# 800 East Denny Way

## Project #3033602-LU Design Recommendation

13 November 2019 | East Design Review Board

entry terrace at southwest corner

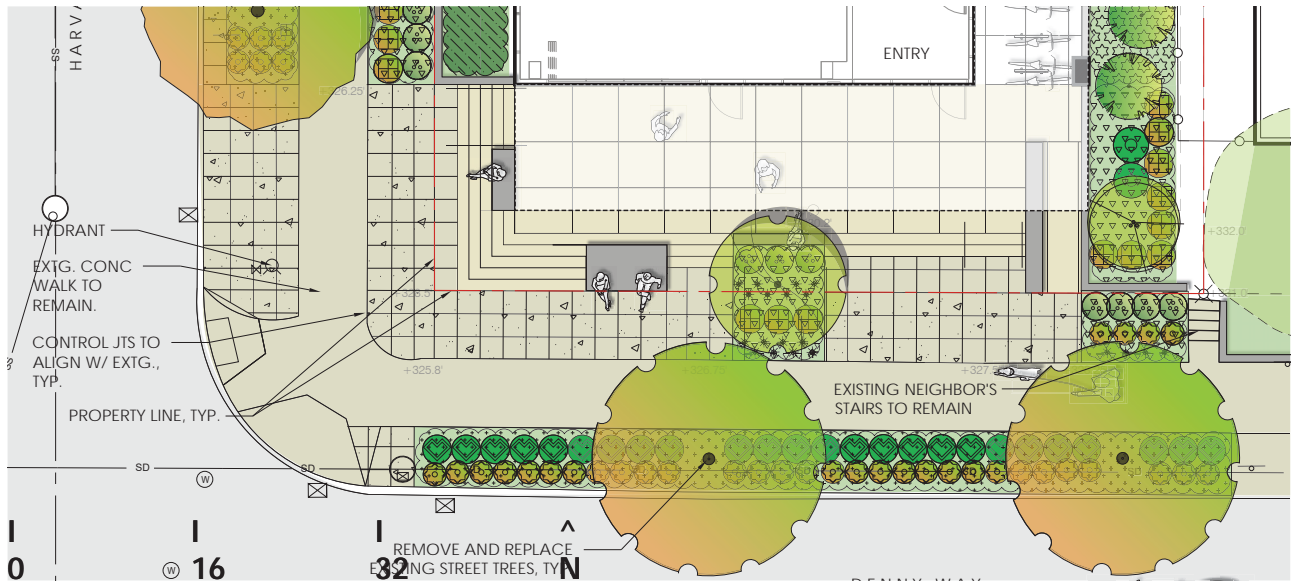
c. The Board also supported the cantilever of the massing over the terrace as an interesting massing move and encouraged study of options to strengthen the legibility of this concept, such as differentiating the base from the upper levels through a reveal or continuing the cantilever at the rear façade.  
(CS2-C-1 Corner Sites, DC2-B Architectural and Façade Composition)

The south cantilever has been maintained. The north side also incorporates a cantilever to strengthen the concept.  
A brick façade is proposed which continues from the ground up through all levels of the building on all sides, so a reveal to differentiate the base from the upper levels is not appropriate.

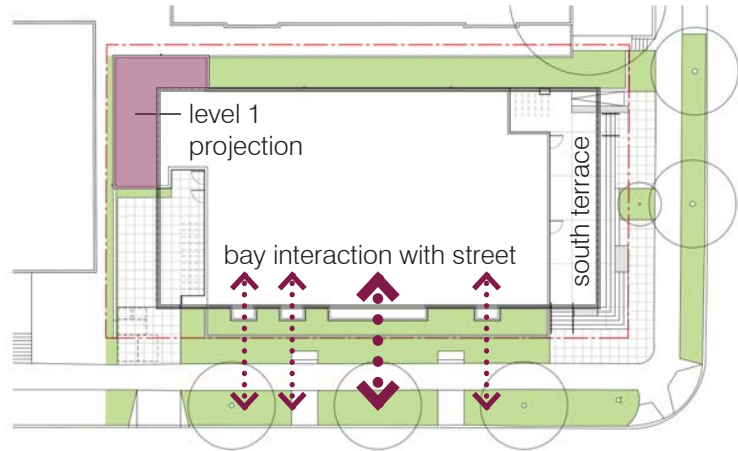
d. The Board agreed that the modulation of the rear (north) façade at the circulation core was not supported by the overall design concept of a simple massing form.  
(DC2-B Architectural and Façade Composition)

The north façade recess at the central circulation has been eliminated in favor of a simple massing form and regular window openings serving each congregate sleeping room programmed along this edge.

6 short term bike stalls at south terrace

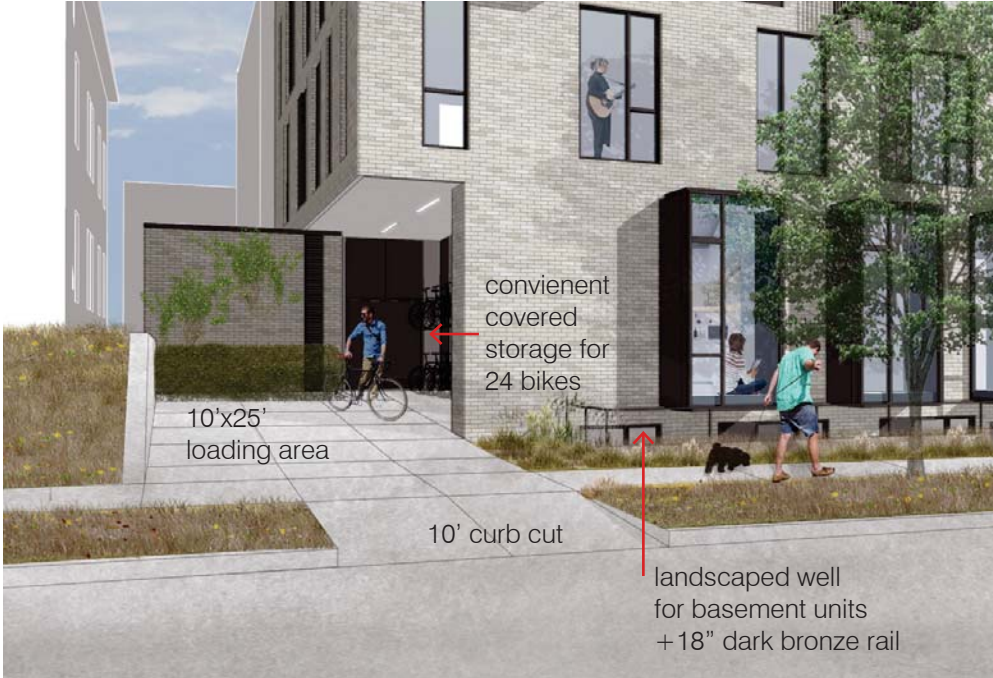
c. The Board was concerned with the proposed location of bike storage in the basement and provided guidance to incorporate bike storage at grade for easier access. The Board is open to bike storage on multiple levels and encouraged a variety of storage options to meet the differing needs of residents. (PL4-A Entry Locations and Relationships, PL4-B Planning Ahead for Bicyclists)

Six short term bike stalls are now provided under cover in the southeast corner next to the residential entry. At the north side twenty-four bikes can be stored under cover using a double stacking rack system accessed from the walking aisle next to the load/unload area. This has convenient access into the building at the north side. All outdoor and covered storage locations will be well lit with soffit integrated down-lighting and low level recessed wall lighting. Additional long term bike storage is maintained in the basement.

commercial space porosity

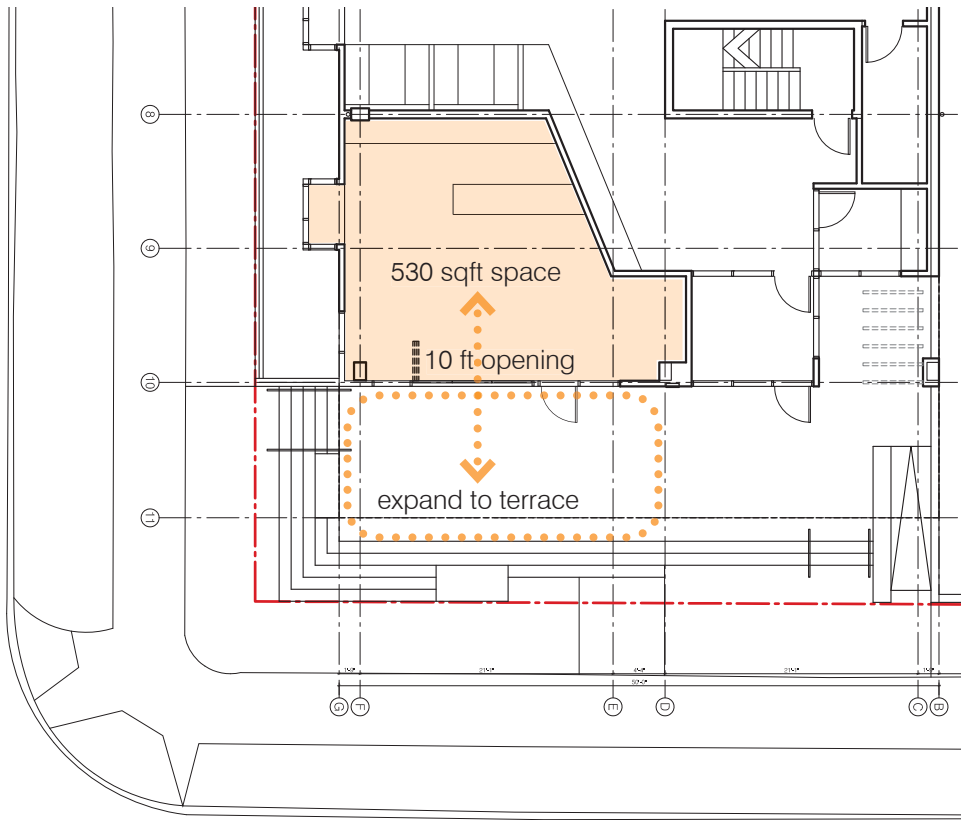
d. The Board expressed some concern with the viability of the commercial unit due to the location above grade and the small size of the space. However, the Board agreed that the location adjacent to the terrace could support a successful space and stated the importance of porosity between the commercial space and the terrace. The precedent image on pg. 37 of the EDG packet illustrating operable windows and outdoor seating was supported. (PL3-C-1 Porous Edge, PL3-I Human Activity, DC1-A-1 Arrangement of Interior Uses)

**Porosity between the 530 sqft commercial space and the covered terrace is proposed using a 10 ft wide by 9 ft tall operable fold & slide window wall adjacent to the entry door.**

generous front yard

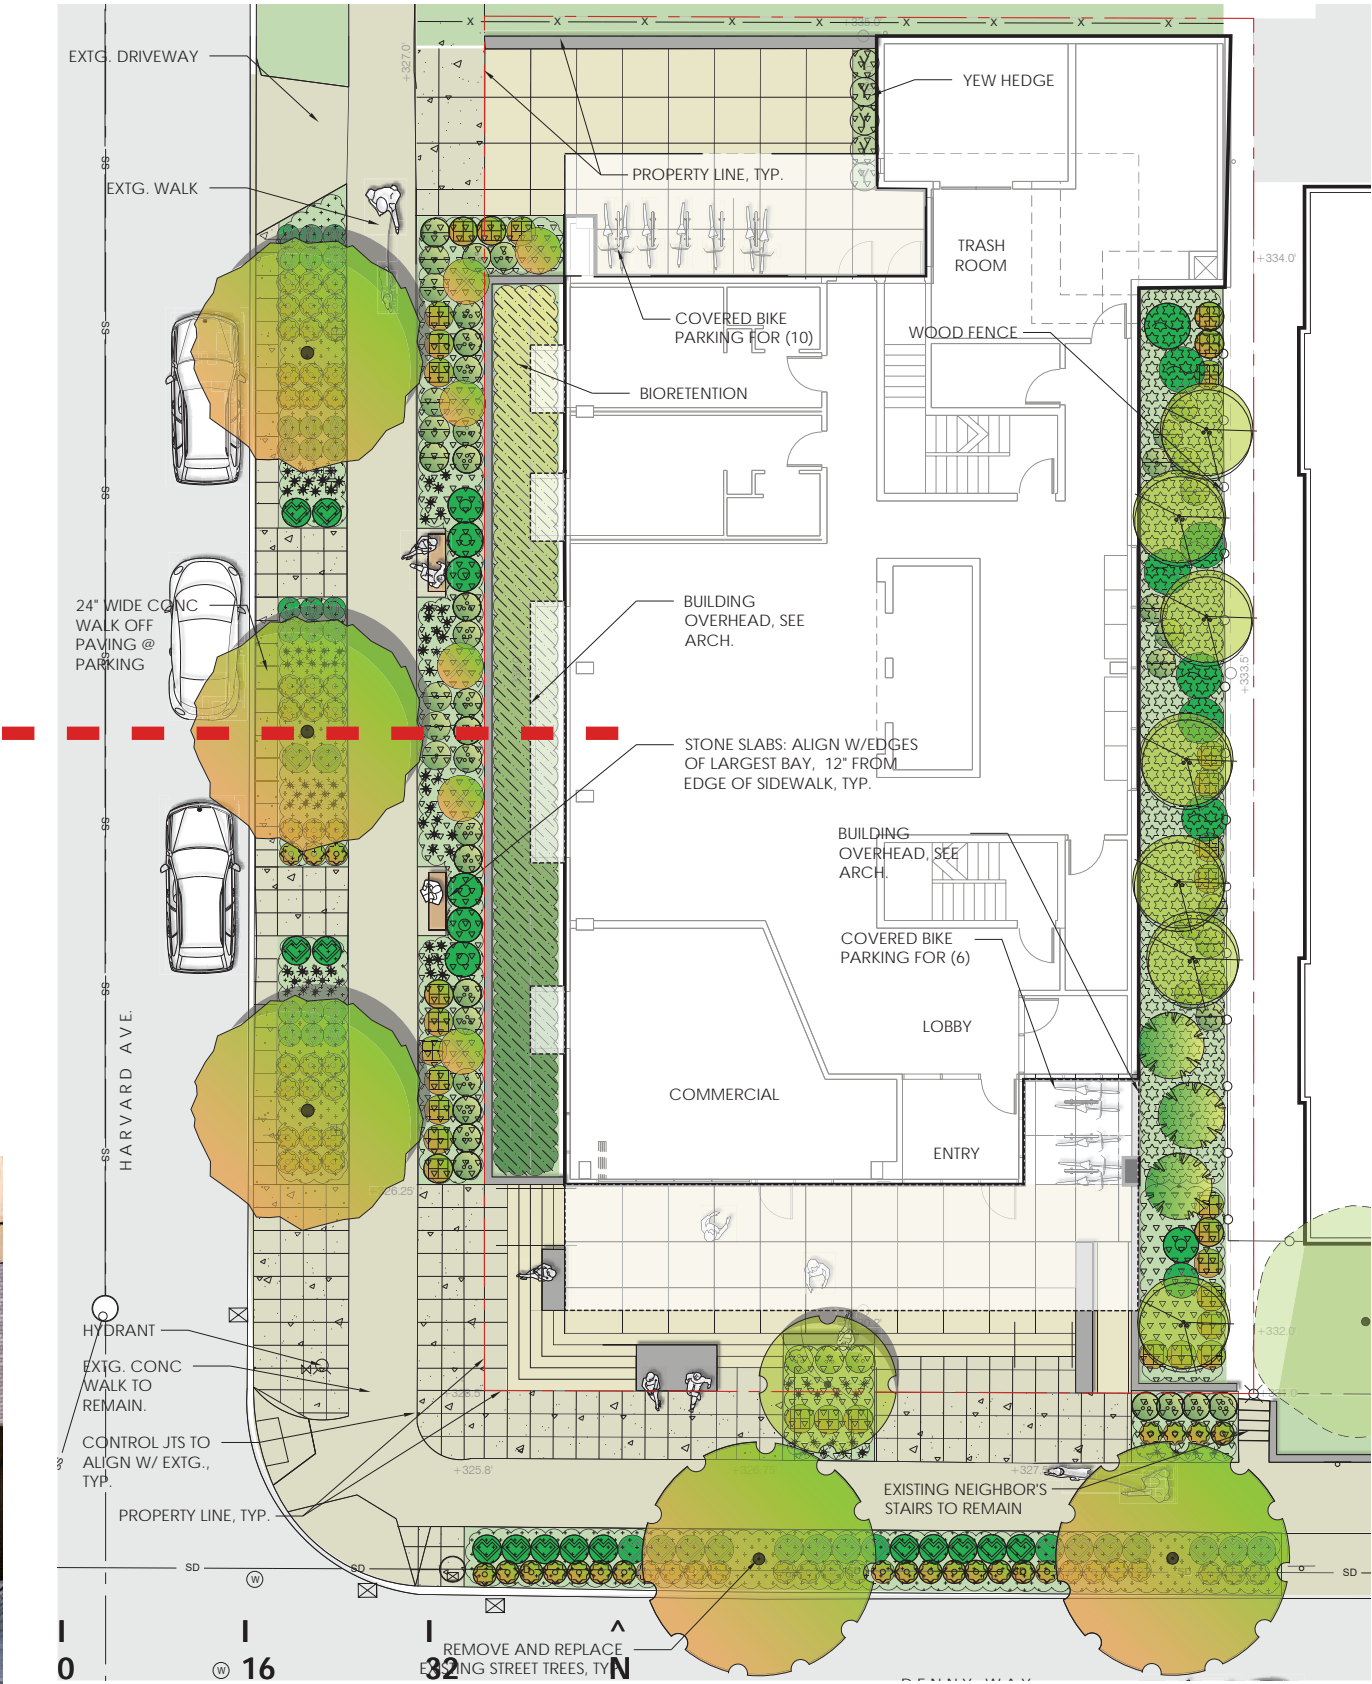
a. The Board generally supported the indicated direction of the landscape concept and observed that the landscaping and hardscaping could be more playful in contrast with the sobriety of the building.  
(DC4-D Trees, Landscape and Hardscape Materials, CS1-D Plants and Habitat)

c. The Board supported the active landscape edge along Harvard and recommended that landscaping be used to frame the projecting bay.  
(DC4-D Trees, Landscape and Hardscape Materials)

The landscape concept has been further developed with Urban Forestry approved street trees, right-of-way plantings, and on site landscaped edges that integrate with the project architecture.

The planting layout is organized with respect to the primary lounge bay including placement of stone slab benches on either side of the bay. The Village Green Zelkova street tree has an axial arrangement to the centerline of the bay. These landscape elements work to frame the architecture.
